ADDENDUM NO. 2
A New Housing Unit for Newberry County Detention Center
Newberry, South Carolina
Newberry County Government
July 23, 2025

Construction Documents for the above project are hereby amended as follows:

S2.1

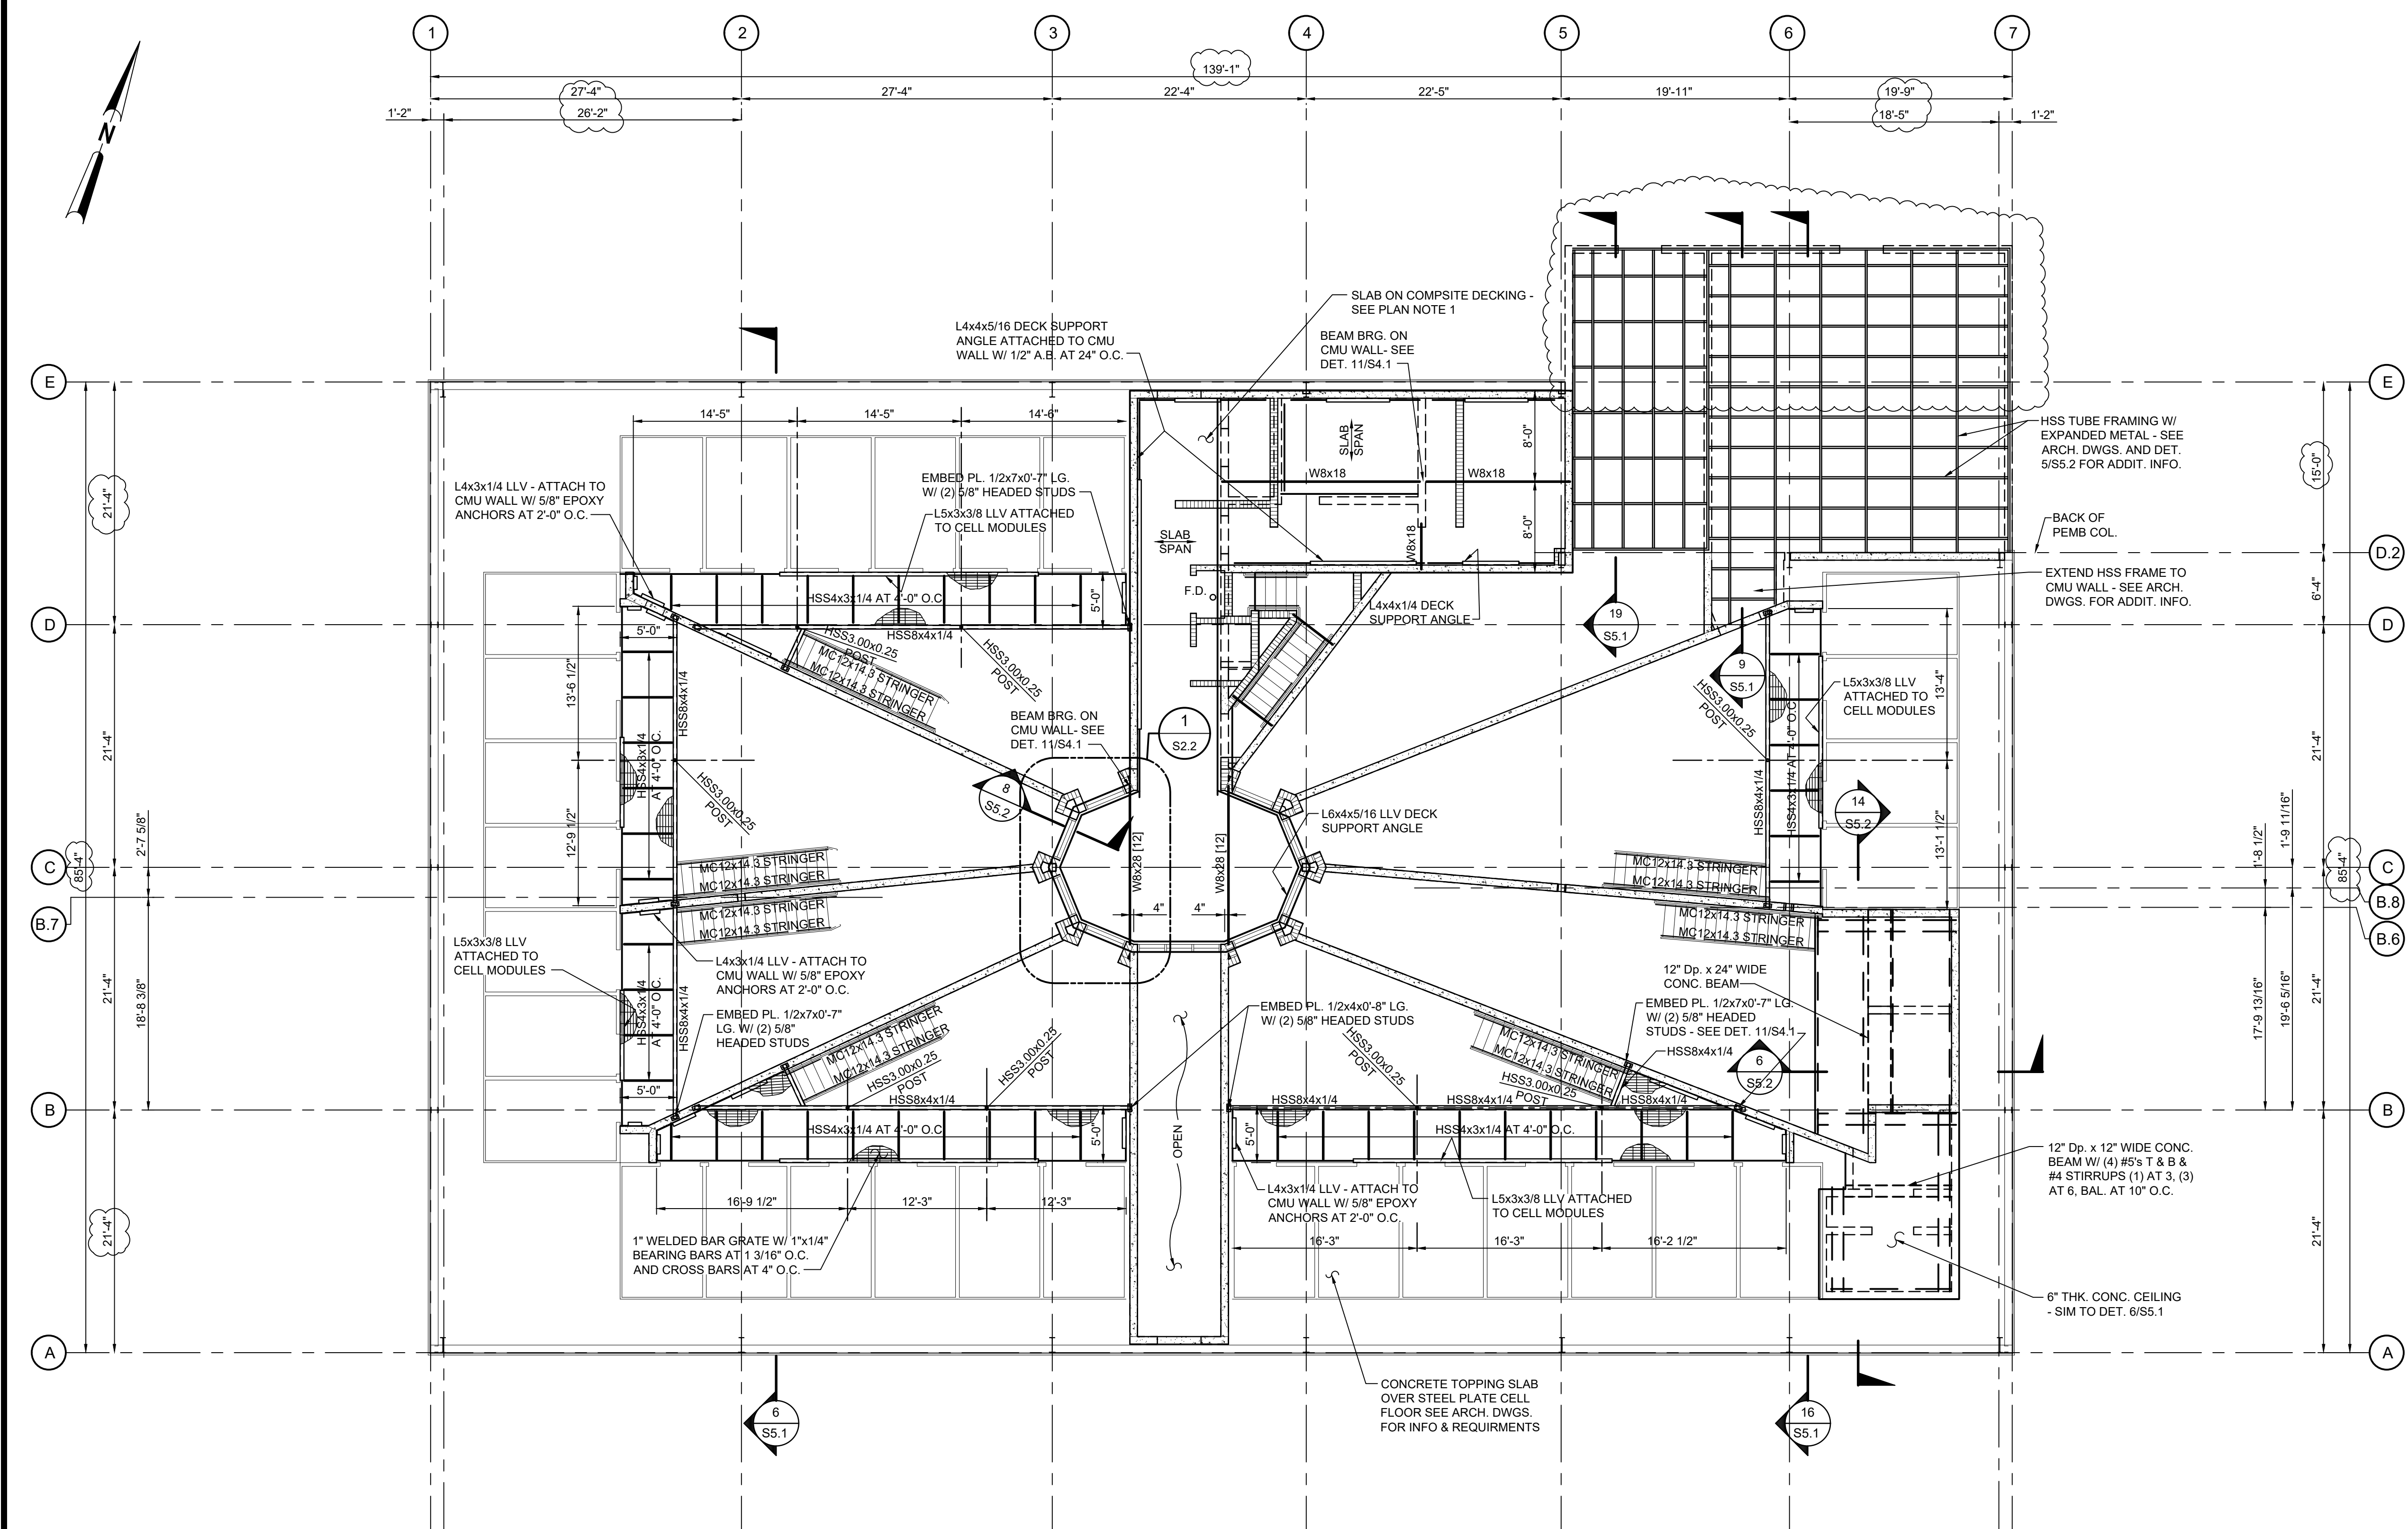
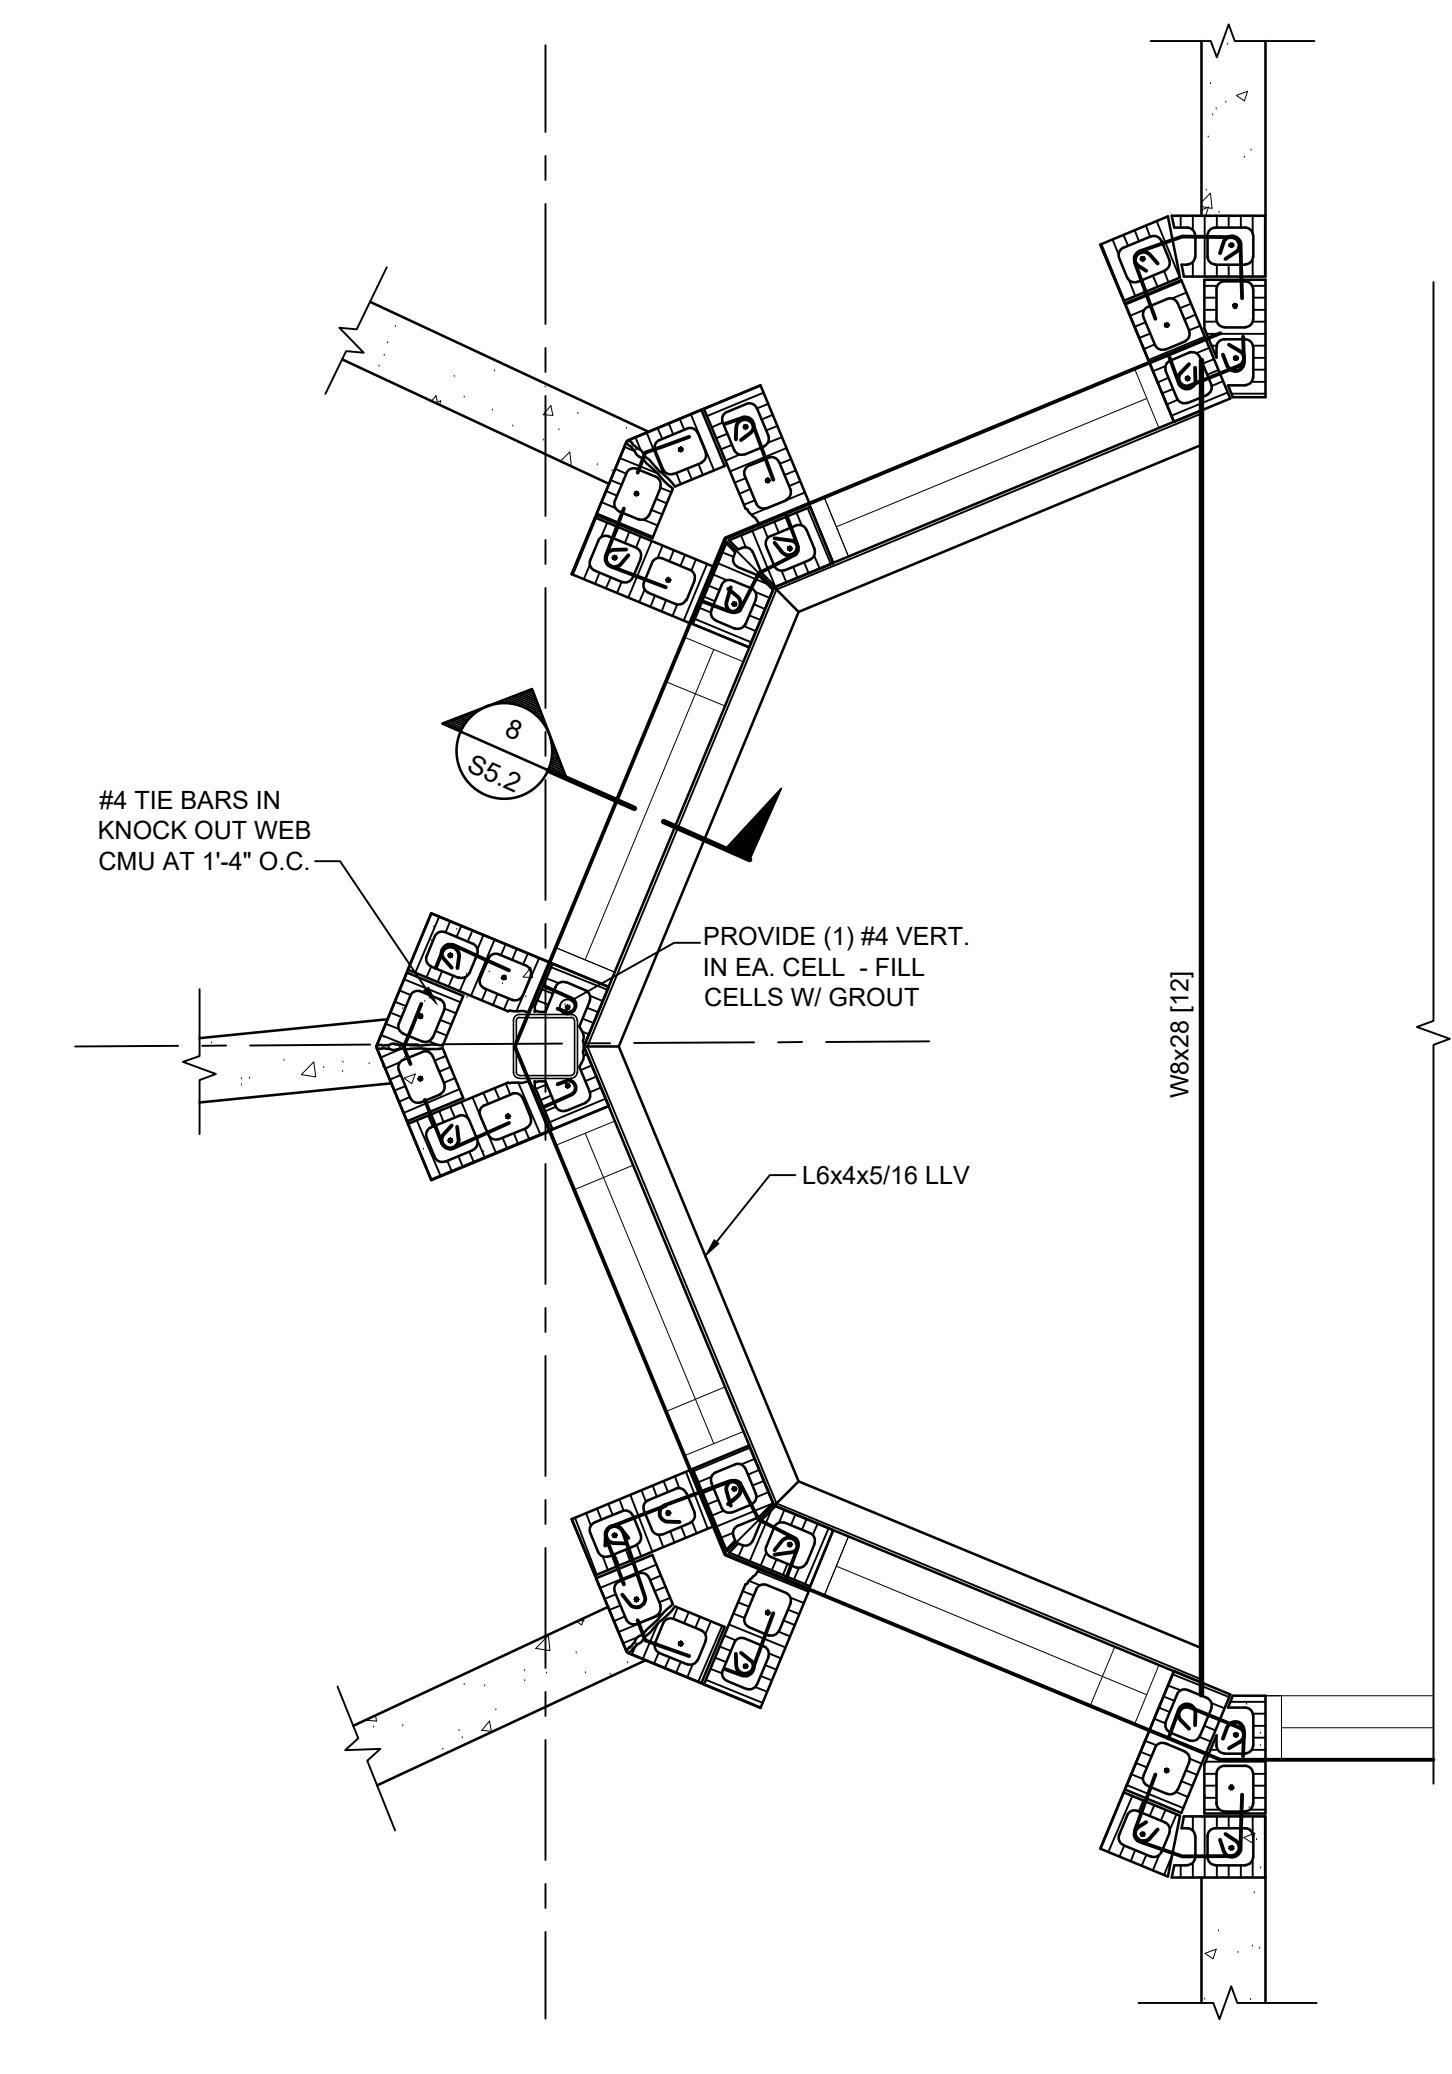
20. Please provide a section that shows the required thickness and reinforcing for the 3'-4" wide footing at the control room shown on 1/S2.1.
See note on Foundation and Slab Plan.
